Answers to Anonymous Referee #2

General comments

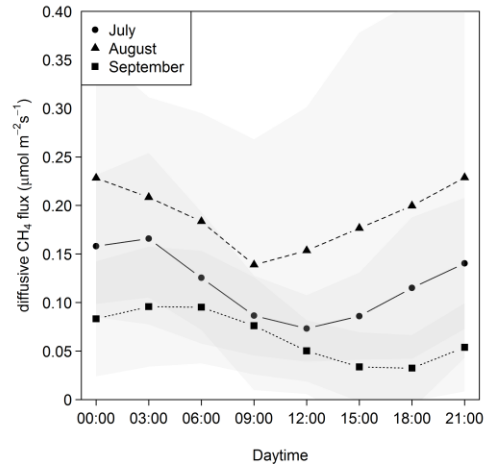
33. Figure 6 – Please show the error bars for the data points. Also, change “Juli” to “July”, and “montly” to “monthly”

We refreshed the figure (see below) and changed “*Juli*” to “*July*” and “*montly*” to “*monthly*” within the figure and figure caption. We now included the standard deviation (SD) as a gray shaded area (indicating the average value \pm 1SD) around the shown development of monthly averaged diffusive CH₄ emissions (please see figure below).
